SUBJECT: Invitation for Bid #12-1144-OV
Second 10 MG Reclaimed Water Storage Tank and High Service Pump Station
At the Southwest Water Reclamation Facility
Manatee County Project No. 6037083

ADDENDUM #1

Attachment #1 – URS Memorandum dated March 29, 2012 responding to questions received at the Pre-Bid / Information Conference held on March 20, 2012 and questions received from Contractors through 5:00 PM, March 27, 2012. (8 Total Pages)

PROJECT STATUS
 PRELIMINARY
 NOT FOR
 CONSTRUCTION
 C-9

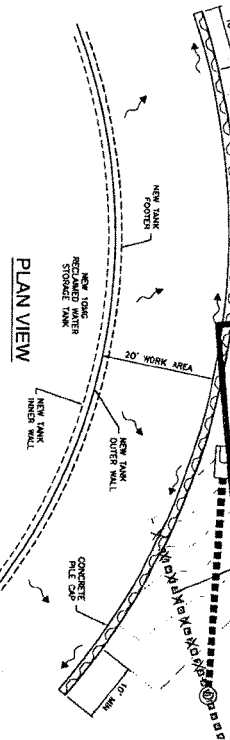
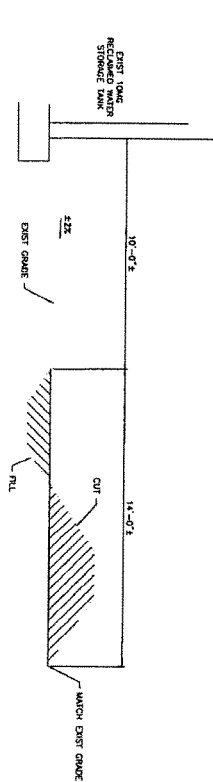
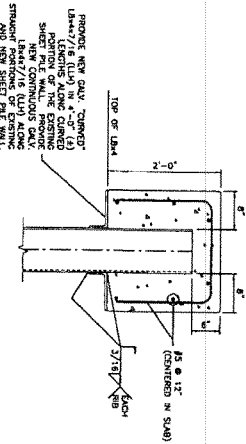
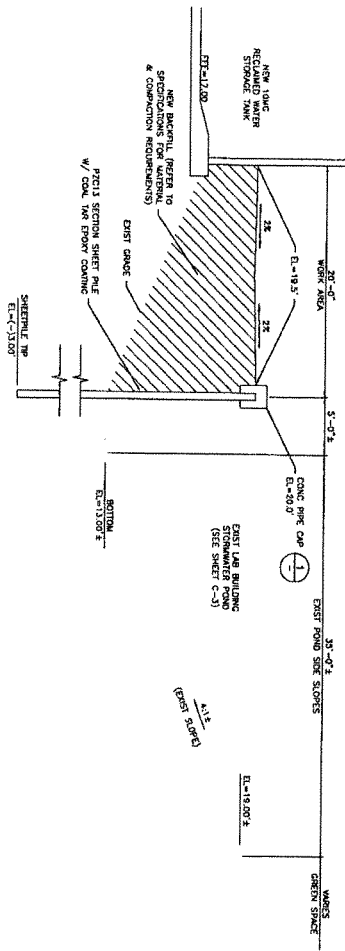
Question 3: Referring to Drawing C-9, Detail 1, "Concrete Pile Cap", please confirm as mentioned at the pre-bid meeting that there is no existing sheet pile wall to attach any item to.

Question 17: Detail 1 on Sheet C-9 refers to existing and new sheet piling. Where is the existing sheet piling?

Question 33: From Section A on Drawing C-9, is it the intent for the final elevation to be 19.50 around the entire tank perimeter or only at the existing stormwater pond?

Question 34: Detail 1 on Drawing C-9 shows a galvanized angle welded to the coated steel sheet piling below the concrete cap. Please confirm the purpose of this angle as it is not a good idea to grind off the coal tar epoxy, which lessens the strength of the sheet, in order to weld the galvanized angle. Also it will

most likely be near impossible to have this angle bent exactly to the shape the sheet piles are installed. If it is the intent for this to be used as a form for the cap, there are temporary "hanging" form accessories we can use to accomplish this. Please confirm if deleting these angles and using hanging forms would be acceptable.

Question 35: On Drawing C-9, please confirm the coal tar epoxy coating for the sheeting is to be both sides of the sheets, 100%.

Question 36: Per Drawing C-4 and Detail B on Drawing C-9, please confirm how deep the existing berm is to be excavated in order to fill the existing swale.

Response 3: The detail is incorrect. There is no existing sheet pile wall, only the proposed one.

Response 17: The detail is incorrect. There is no existing sheet piling, only the proposed one.

Response 33: The proposed elevation of 19.50 is in the vicinity of the existing stormwater pond. For the remainder of the tank perimeter, grade should be approximately 18.5, sloped back to existing grade.

Response 34: The purpose of the angles is to act as a form for the pile cap. Alternative methods can be utilized.

Response 35: Yes, the coal tar epoxy coating should be on both sides of the sheet pile.

Response 36: The goal of this detail is to re-grade the area in order to eliminate the swale and berm so that there is a gradual slope away from the tank.

LANDSCAPE PLAN

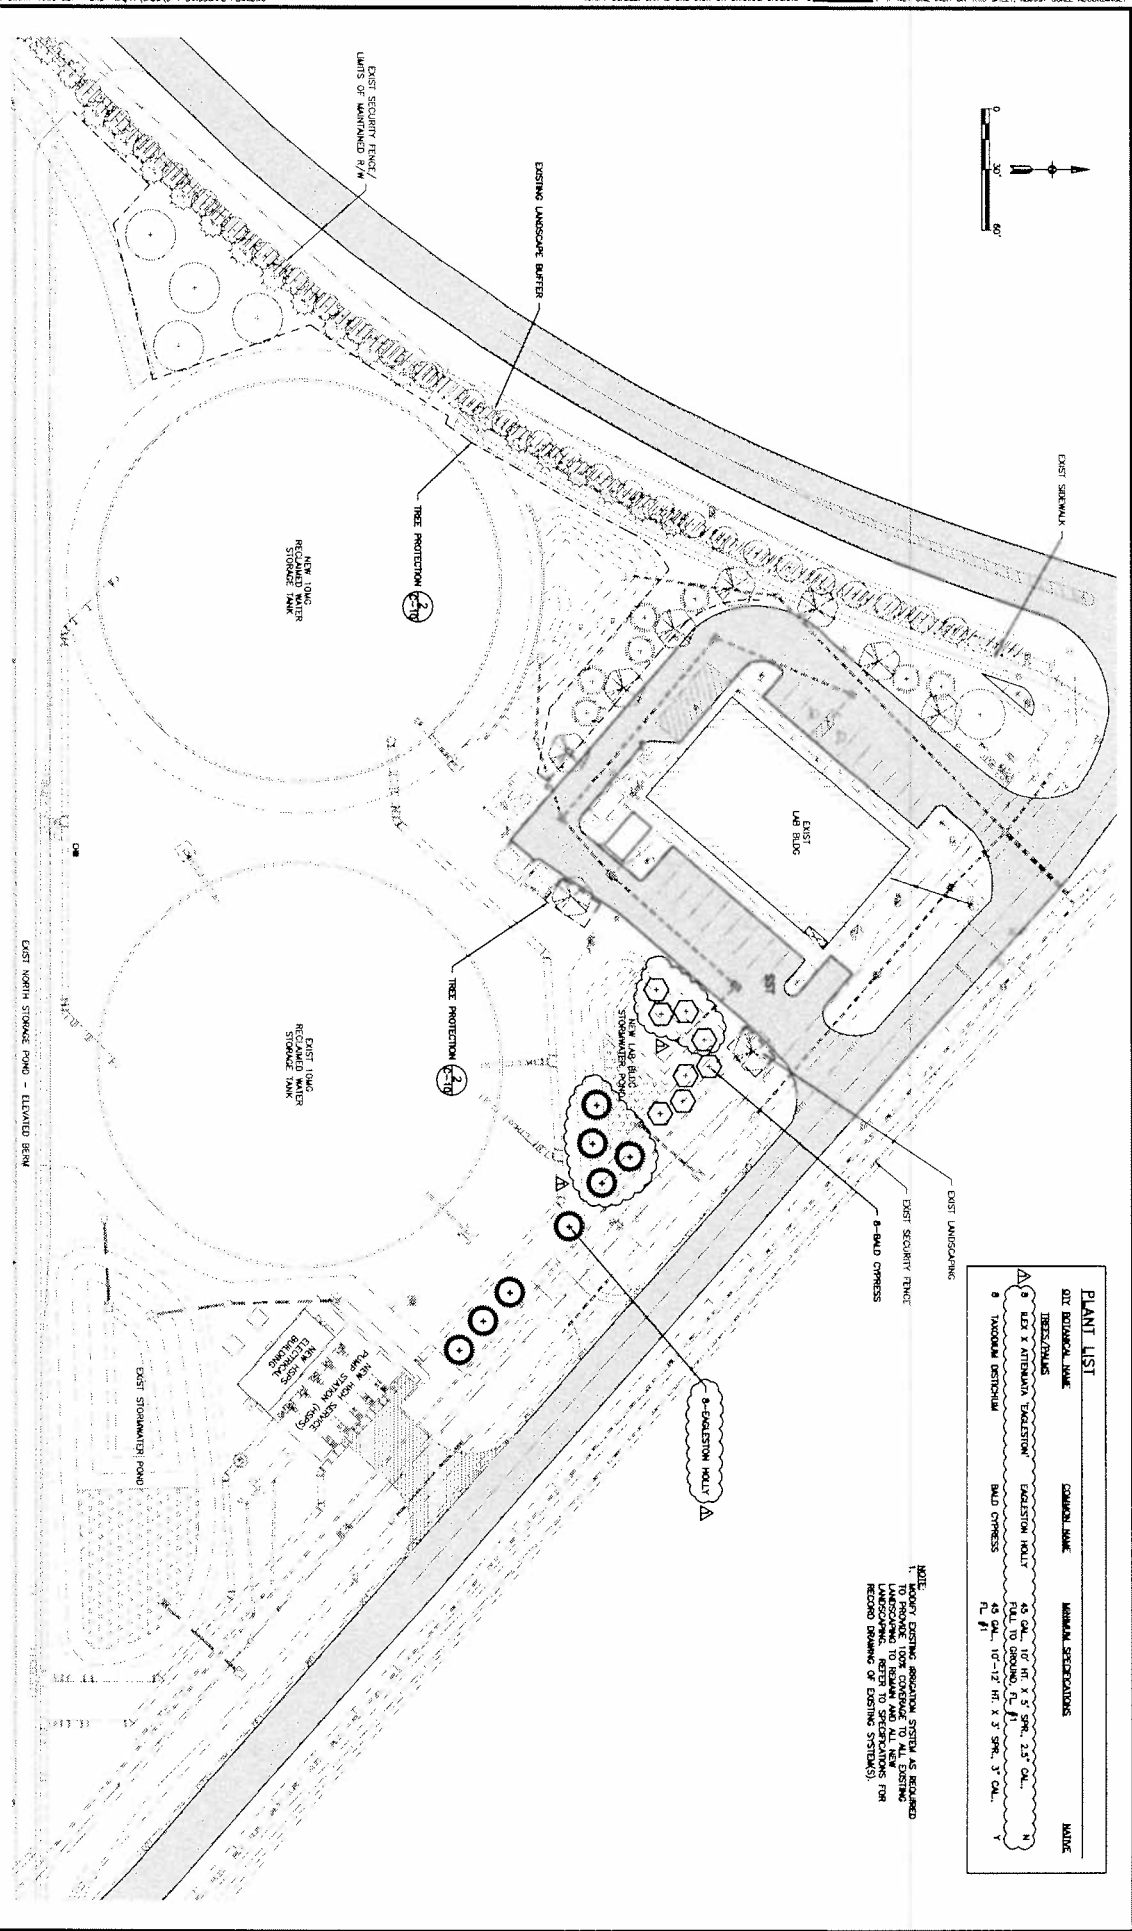
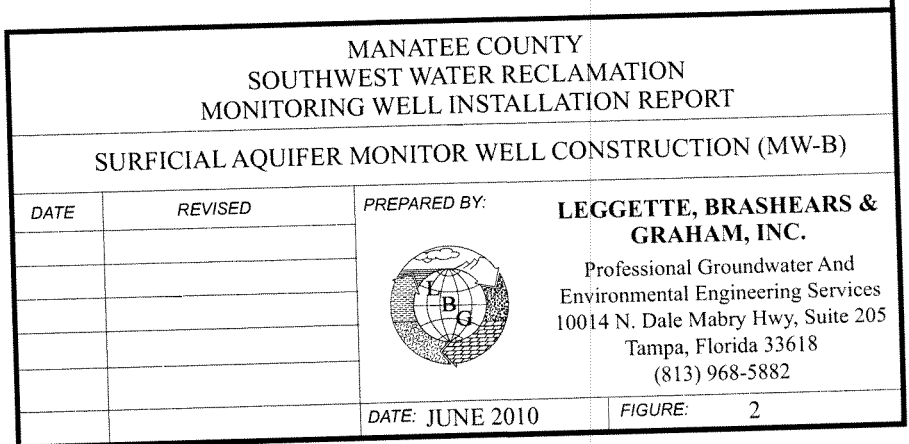
Question 7: DWG L-1 refers to record drawings for irrigation per specifications, none provided. Please clarify.

Response 7: The two record drawing sheets are part of the specifications. They are located at the end of the specifications, after the Geotechnical Report, in section Supplemental Information, Irrigation Record Drawings.
